DEVELOPMENT DETERMINATION PANEL MEETING

WEDNESDAY 14 FEBRUARY 2024

ITEM 3.1 REV2023/0022 - 16 CORELLA STREET FRESHWATER - REVIEW OF DETERMINATION OF APPLICATION DA2022/2237 FOR SUBDIVISION OF ONE LOT INTO TWO INCLUDING DEMOLITION WORKS

REVIEW OF DETERMINATION ASSESSMENT REPORT

Figure 1: Section taken of the alterations and additions showing the building height non compliances

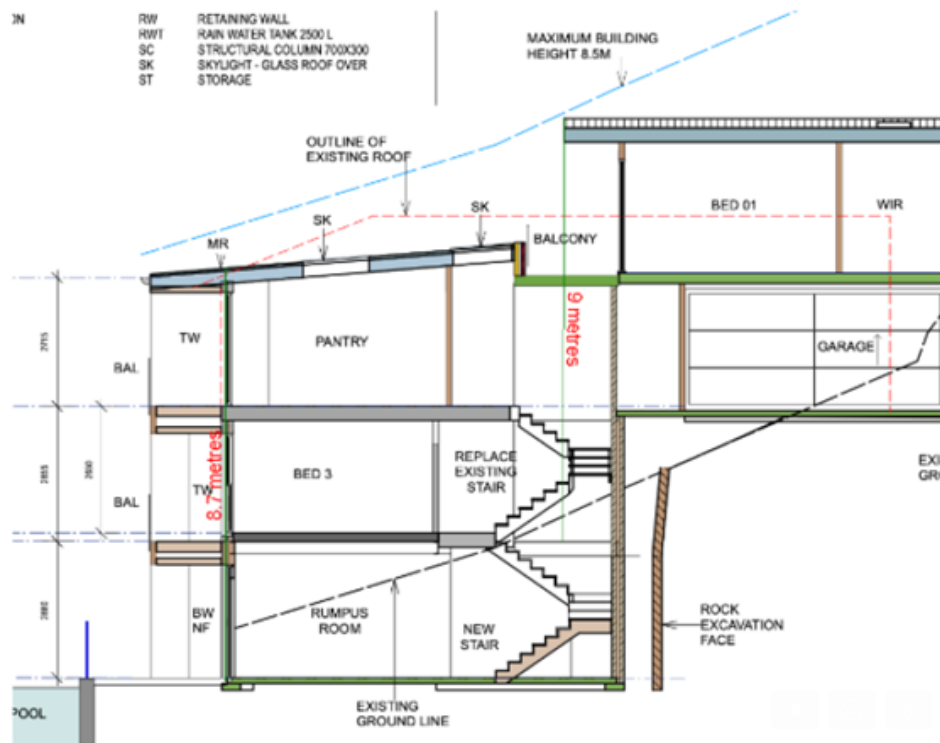
- The main breach occurs due to the overhang of the eaves of the first floor addition above the garage which overhangs down to the existing excavated lower level of the original 3 storey dwelling. The rear façade of the addition would be compliant with the development standard. The eaves are a minor element of the design and does not result in any unreasonable visual impact as a result of the non-compliance. See *Figure 1* for further detail.

It is considered that the breach of the height of buildings control is a result of the existing excavation on site and is limited to the alterations and additions within the existing building envelope and footprint. Council agrees with the applicants argument and supports the stepping of the dwelling with the topography of the site. In addition, the proposed new upper storey readily complies with the maximum building height and is considered to be consistent with the objectives of the control.

Image 3 - View from north-eastern balcony adjoining living room of 6 Halesmith Road.
Prepared by Action Plans.

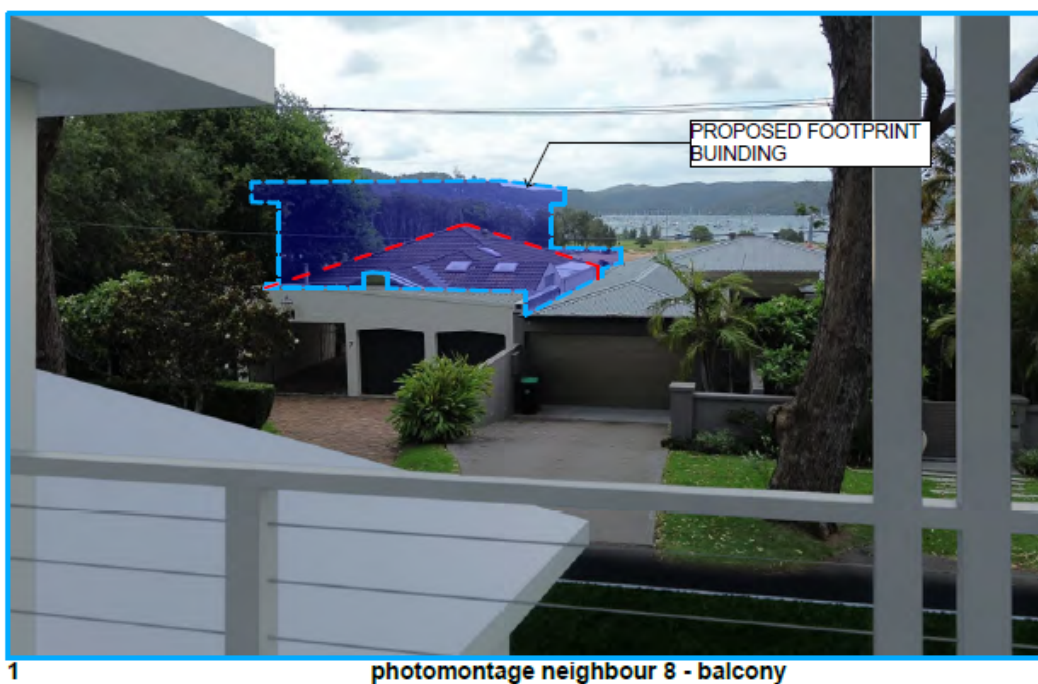
The view from the north-eastern balcony (adjoining living room) loses a minor portion of water views and minor portion of views of the dog park. However, a high quality proportion of water views are still maintained and this includes land water interface, moored sail boats and long distance views to Ku-ring-gai national park. See image 3 below:

The overall level of impact taking into account the amount and quality of views retained when compared to those views impact, is considered to be minor, given that primary views from the living room are largely retained. The area which is most impacted, being the bedroom, still retains good quality water views (approximately 50%) beside the new upper floor.

Image 4 - View from upper level balcony adjoining living room of 8 Halesmith Road. Prepared by Action Plans.

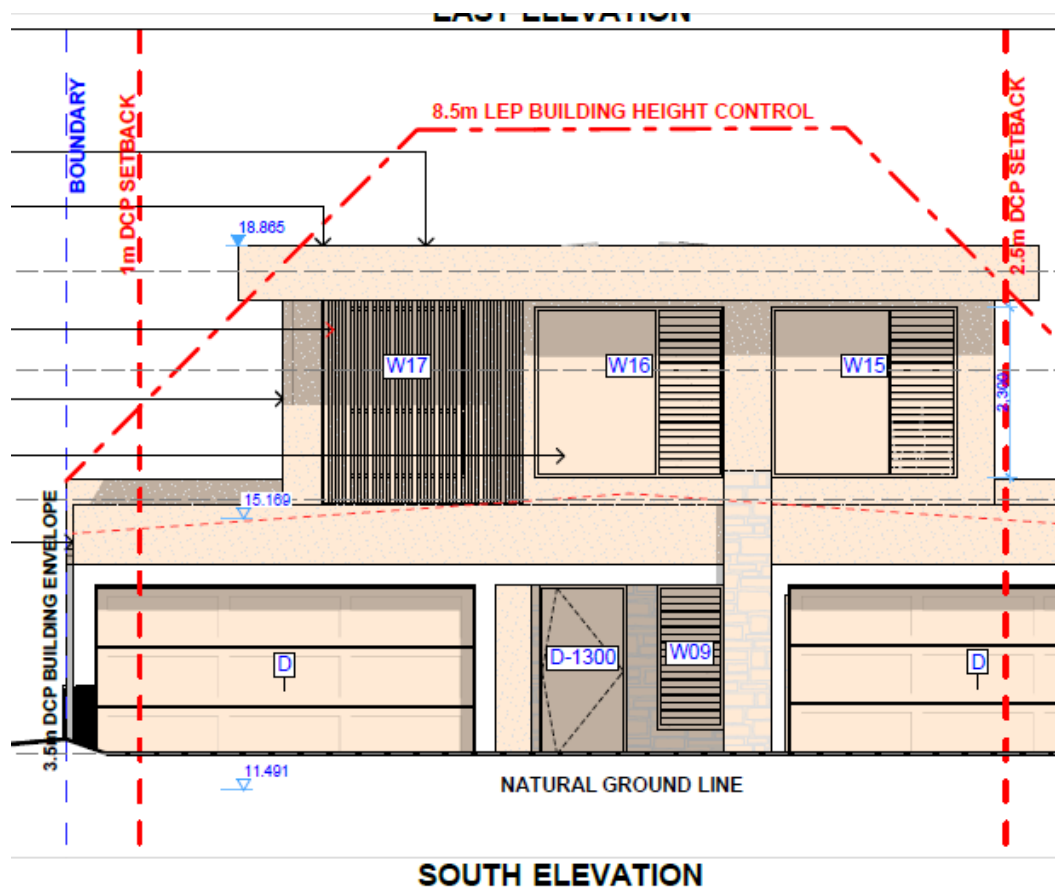
The view impact from the property 8 Halesmith Road is considered to be minor, given it is only a small portion of the view towards the dog park which is impacted and whole water views are retained.

Figure 1. Section BB (red highlighting height of building non-compliance)

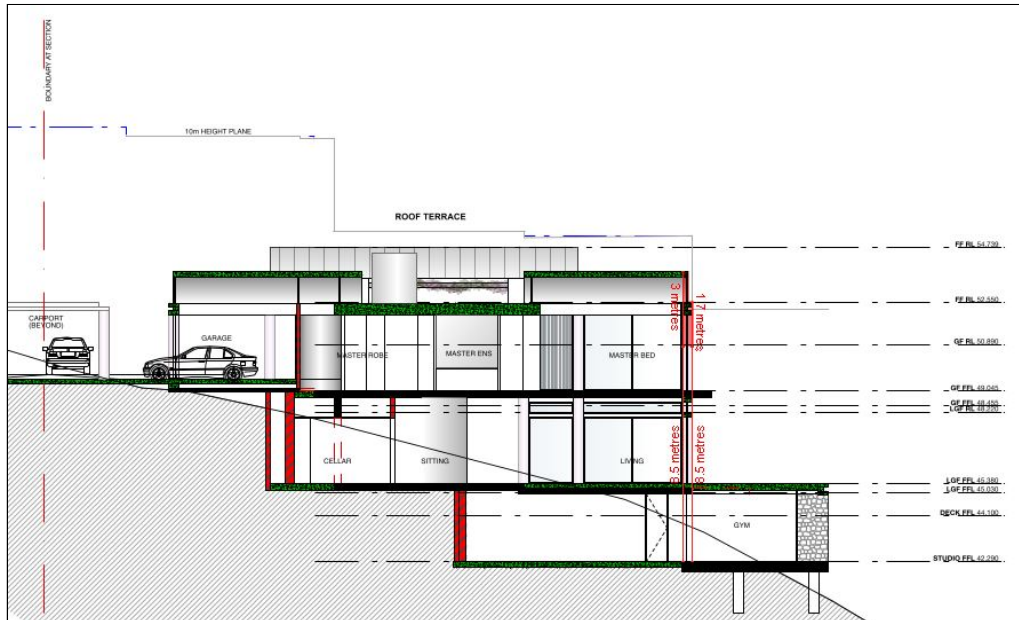
The proposed development presents a maximum height of 11.5m, presenting a variation of 35.29% (3.0m) to the required 8.5m development standard (see Figure 1) of Clause 4.3 Height of buildings of Pittwater Local Environmental Plan 2014 (PLEP 2014).

Figure 3. North Elevation (red highlighting numerical building envelope non-compliance)

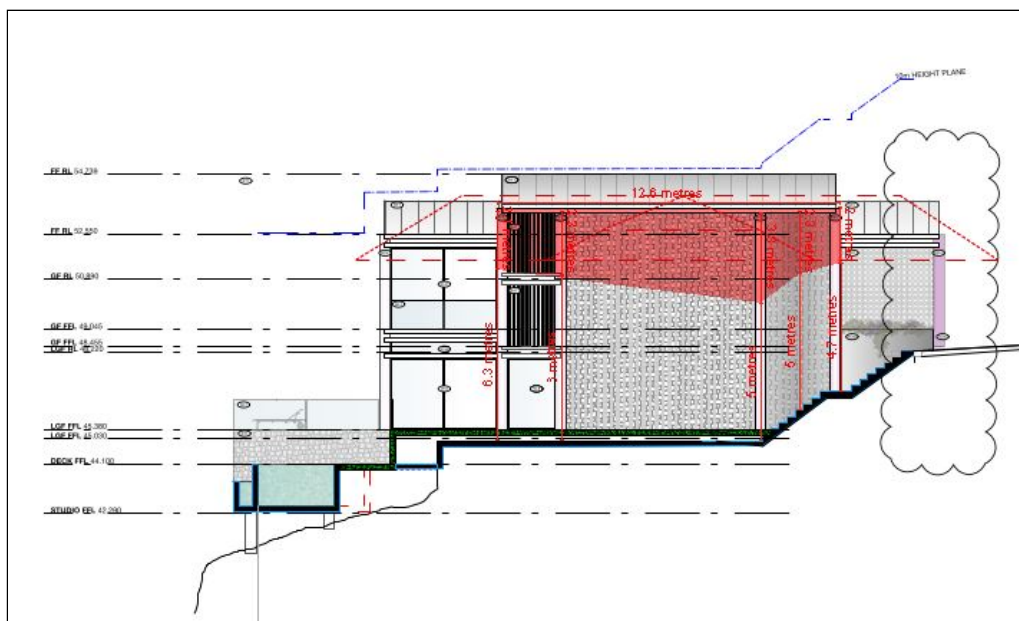
The proposal presents a variation to the building envelope control along the North Elevation, presenting a maximum variation of 66% (3.3m in height for the length of 12.6m) as depicted in Figure 3.

Figure 4. South Elevation (red highlighting numerical building envelope non-compliance)

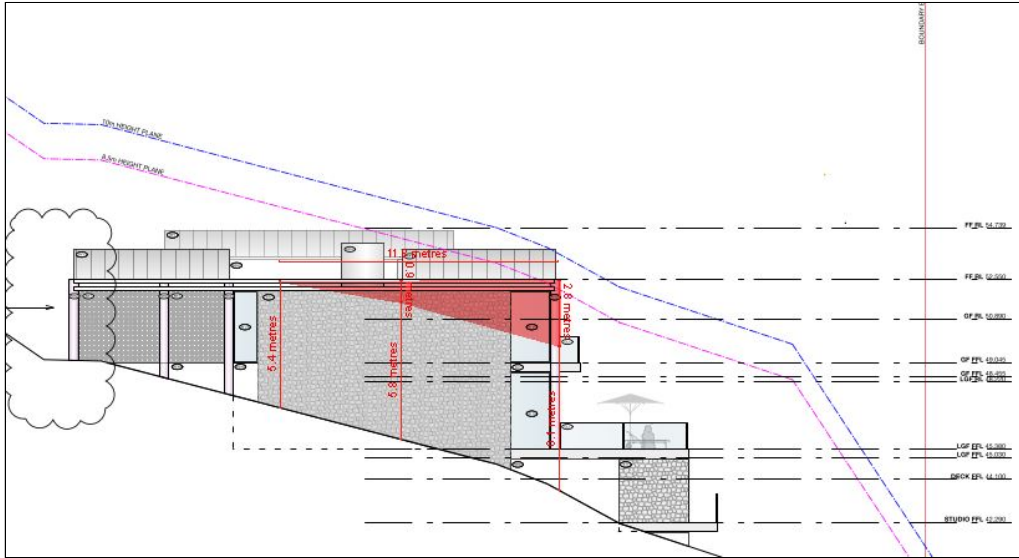
The proposal presents a variation to the building envelope control along the South Elevation, presenting a maximum variation of 45.90% (2.8m in height for the length of 11.8m) as depicted in Figure 4.

Figure 1. Proposed maximum building height (breach indicated in green shading).

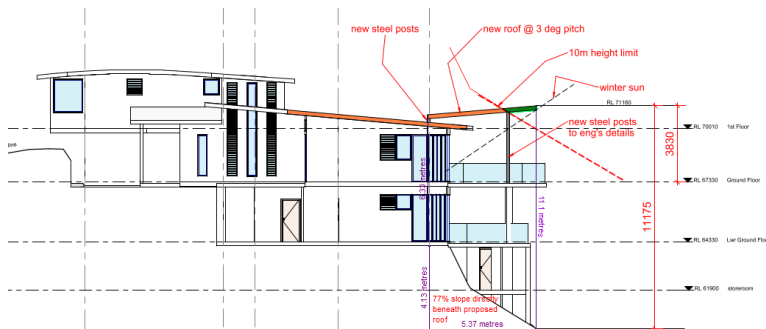
Percentage of variation: 11%

Figure 2. Eastern elevation side boundary envelope, breach indicated by green shading.

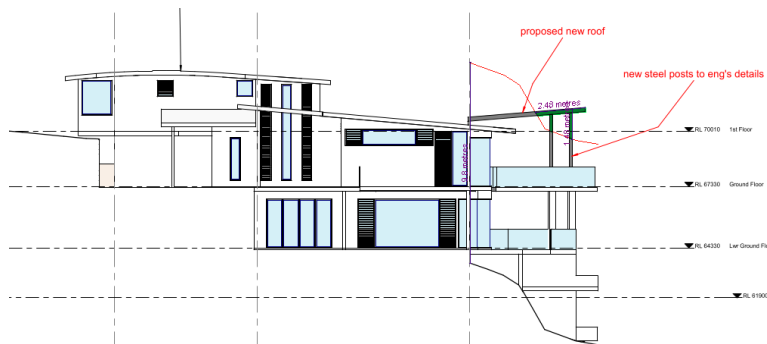
This control requires development to be sited within a building envelope, which is measured at a height of 3.5 metres from the side boundary and then projecting plans angled inward at 45 degrees. Notwithstanding the significant eastern side boundary setback distance, the proposal extends beyond the prescribed side boundary envelope to the eastern elevation, as indicated in the figure below. However, this control permits a variation to exceed the side boundary envelope where the building footprint is located on a slope of 16.7 degrees (that is, 30%). The roof form is sited over the existing building footprint that is located on a slope of 77%. Therefore, the variation can be applied, in this instance.
